**ADDENDUM NO. 1 TO PROJECT NO. 47208**

**HVAC AND ELECTRICAL WORK  
REPLACE HEATING SYSTEM OFFICE AND GARAGE  
DOT REGION 8, DUTCHESS COUNTY  
HOLLOW ROAD AND TACONIC PARKWAY  
CLINTON CORNERS, NY**

May 9, 2023

REF: NONE SCALE: NTS

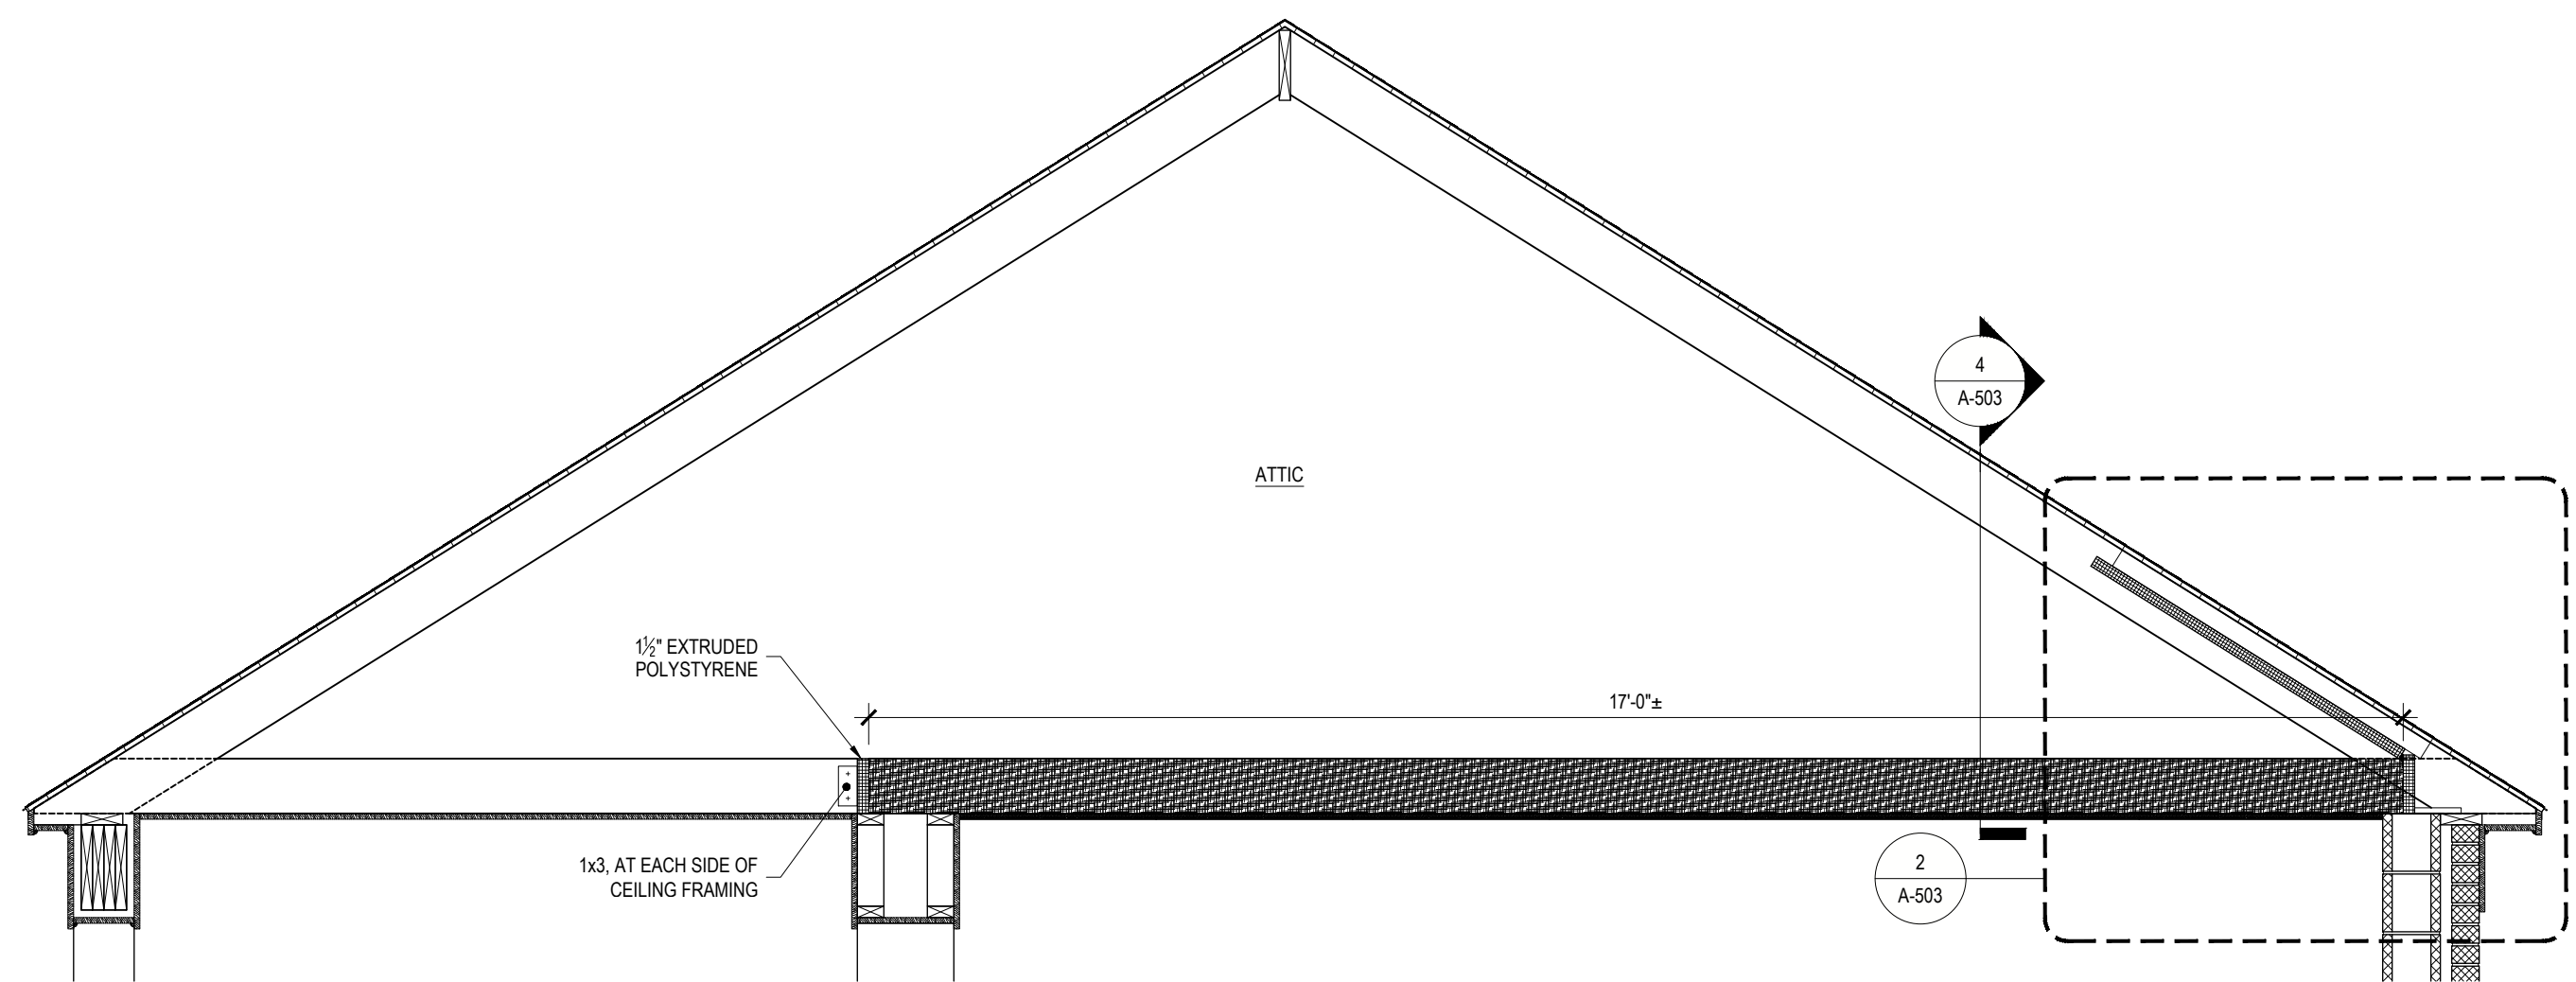
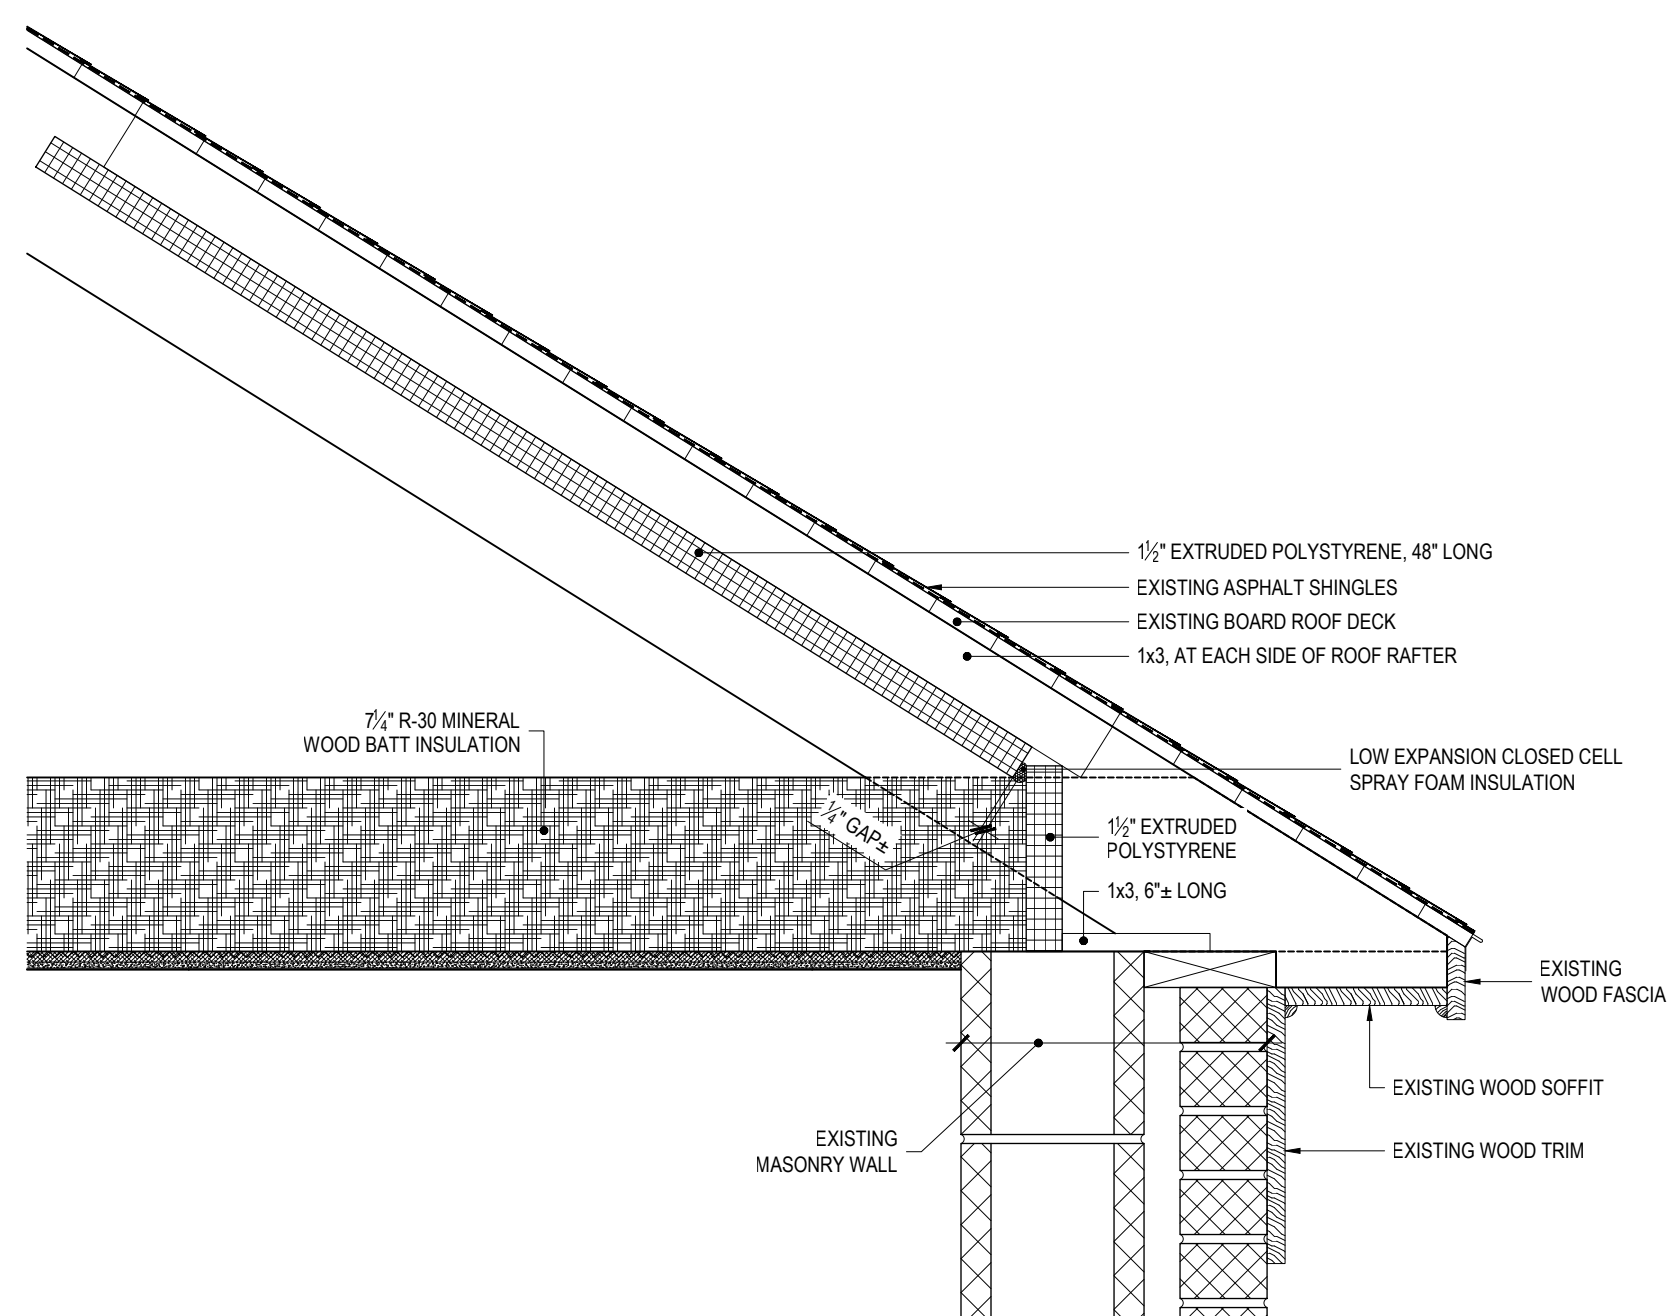
2. Revised Drawings:
  - a. Drawing Nos. G-002, A-101, A-501 and M-102, noted “REVISED DRAWING 05/08/2023”, accompany this Addendum and supersede the same numbered originally issued drawings.
3. Addendum Drawings:
  - a. Drawing No. A-503 noted “ADDENDUM DRAWING 05/08/2023”, accompanies this Addendum and forms part of the Contract Documents.

FIRST FLOOR ELECTRICAL PLAN

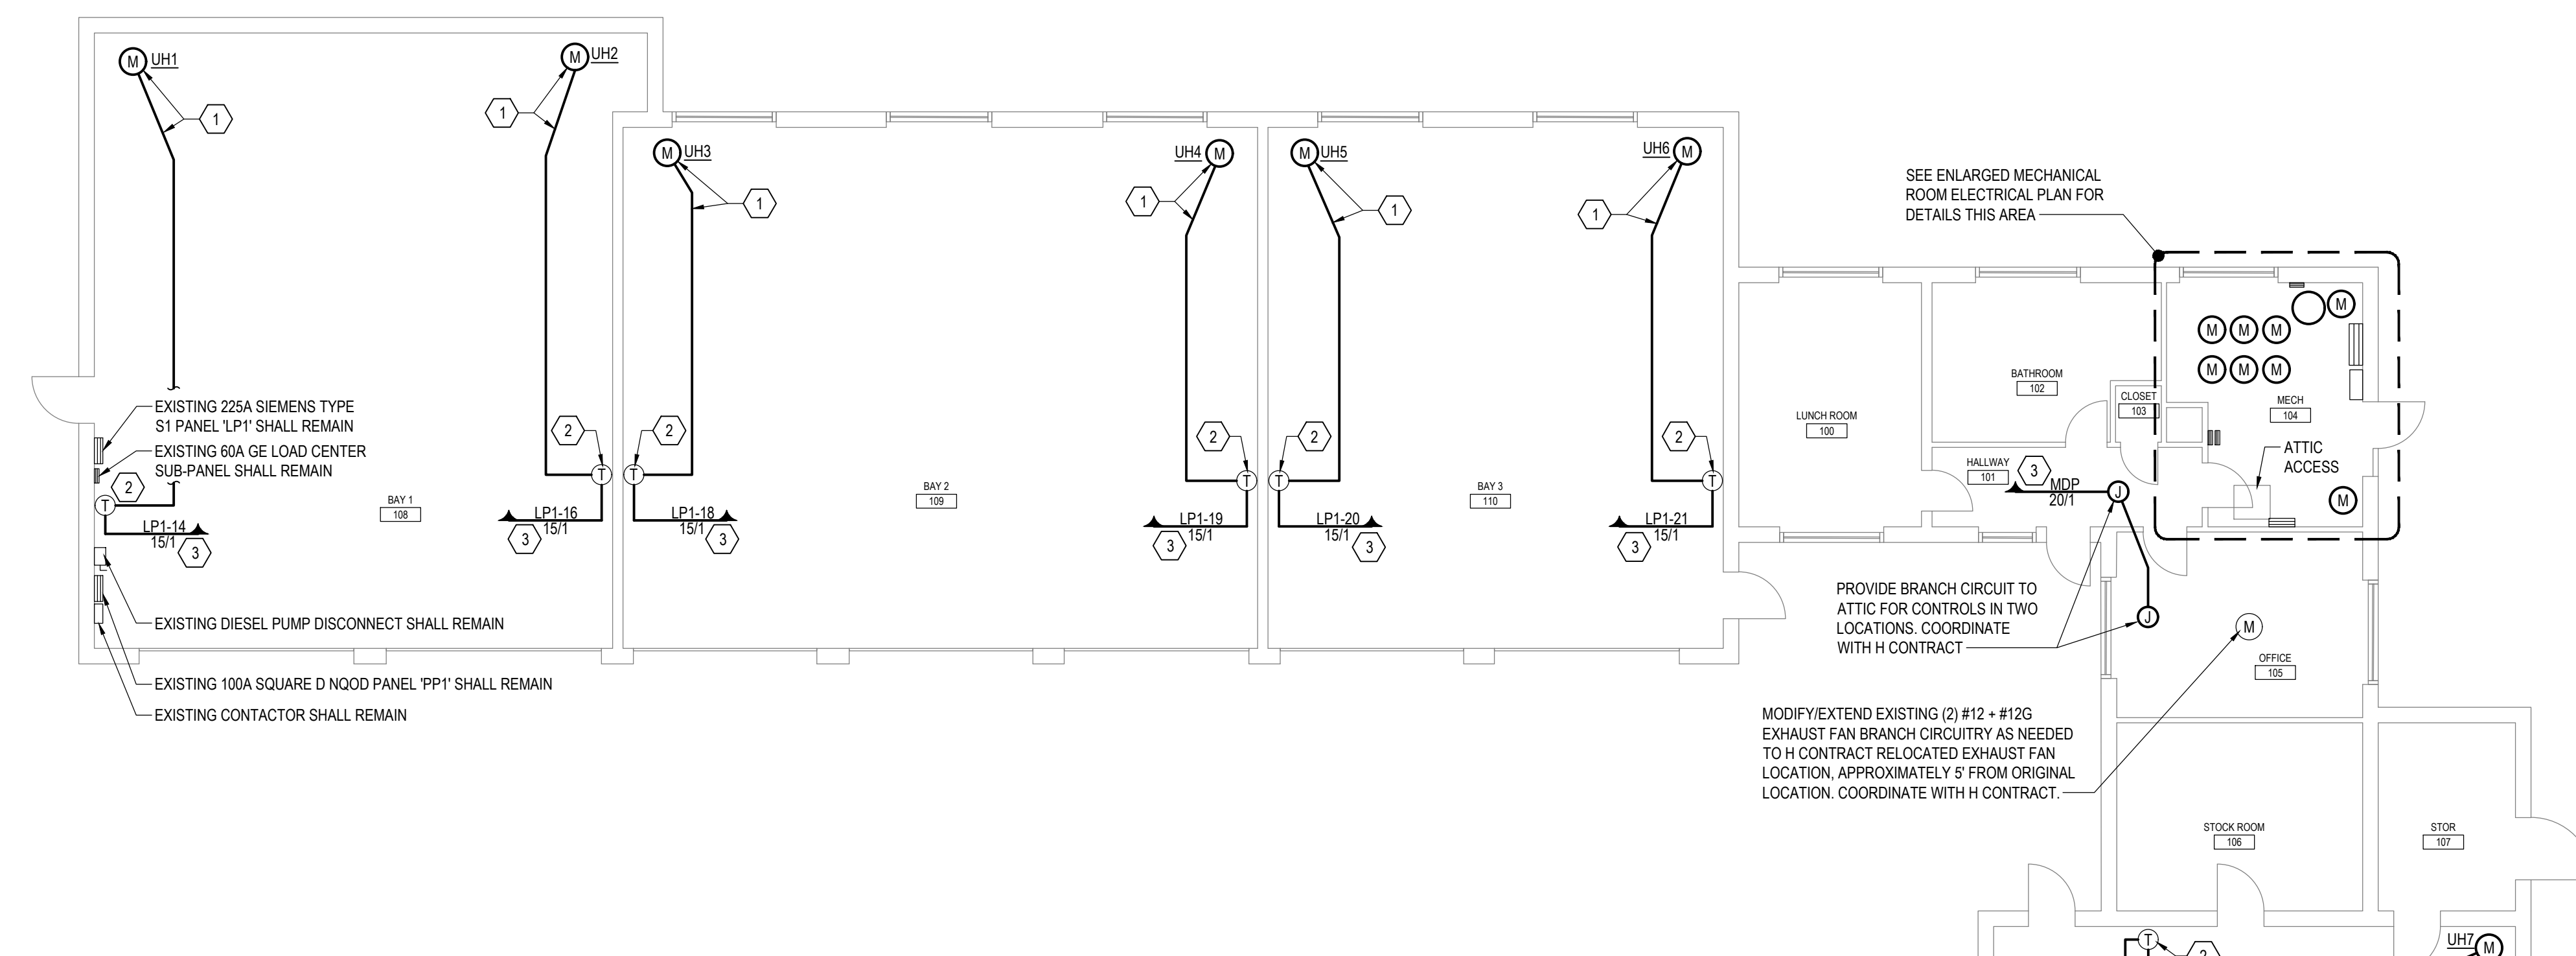
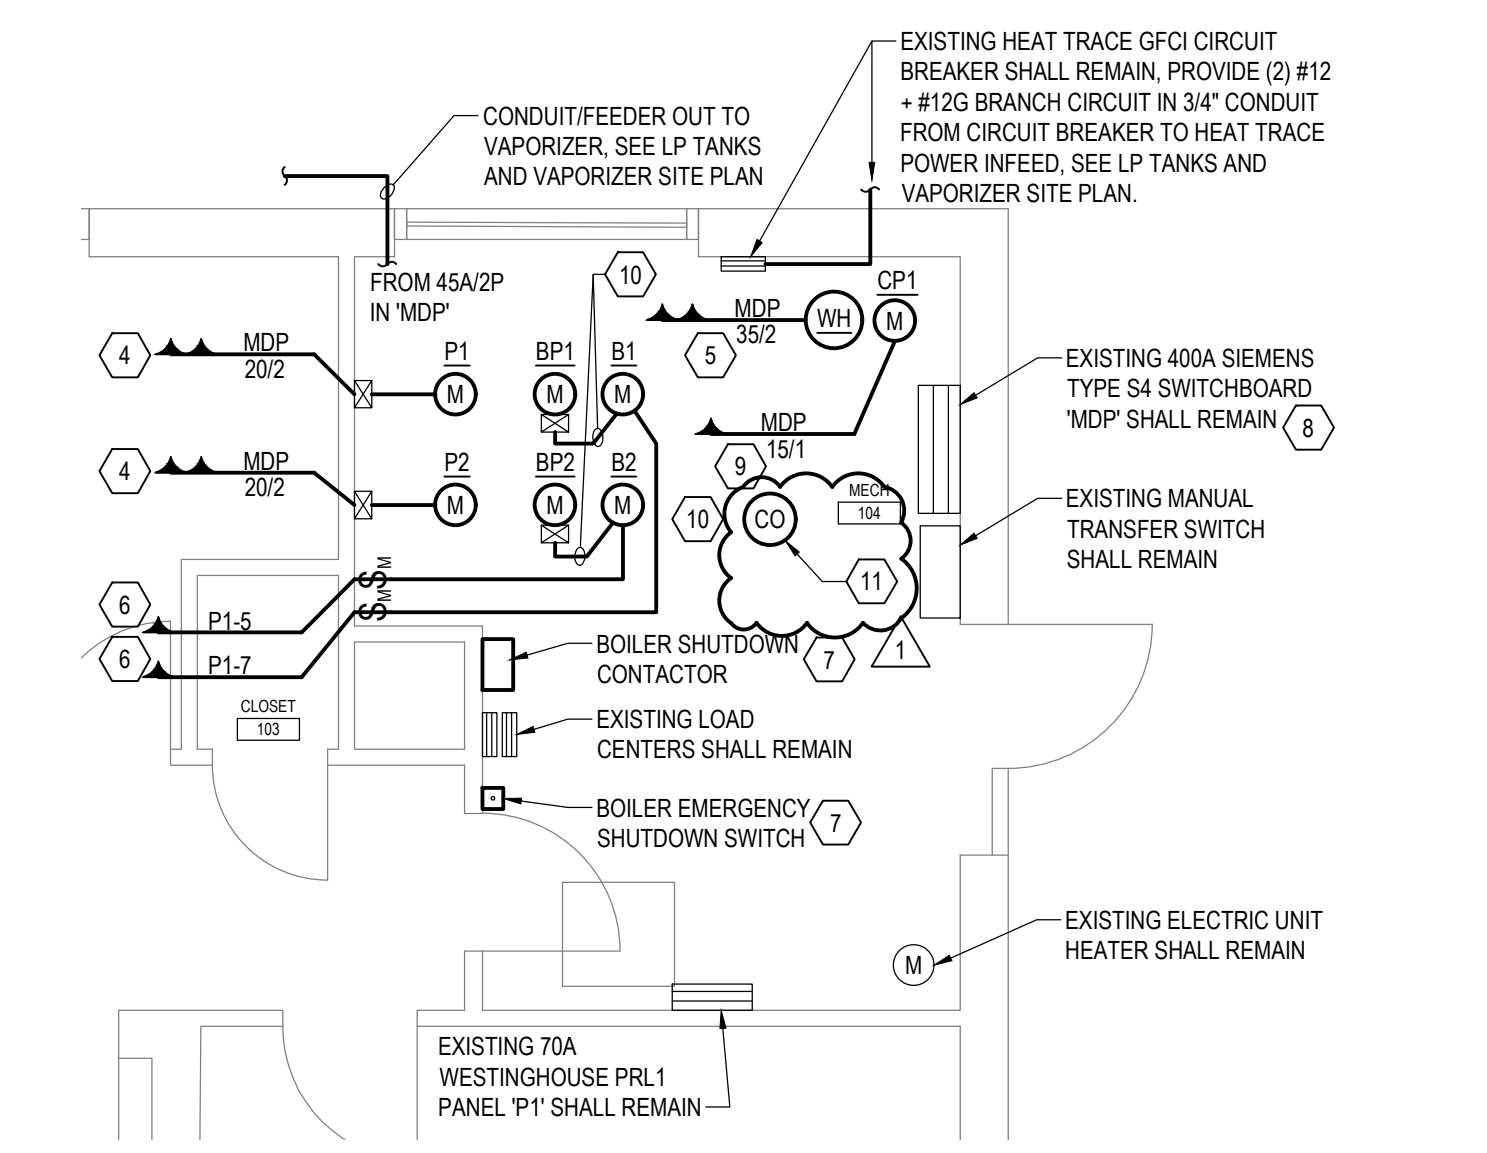
4. Revised Drawings:
  - a. Drawing No. E-101, noted “REVISED DRAWING 05/08/2023”, accompanies this Addendum and supersedes the same numbered originally issued drawing.

- PROVIDE (2) #12 + #12G BRANCH CIRCUIT IN 3/4" CONDUIT FROM BOILER CONTROLLER TO BOILER PUMP CONTROLLER. COORDINATE WITH H CONTRACT.
- PROVIDE STAND ALONE CARBON MONOXIDE DETECTOR WITH LOCAL SOUNDER BASE, AND 10 YEAR BATTERY.
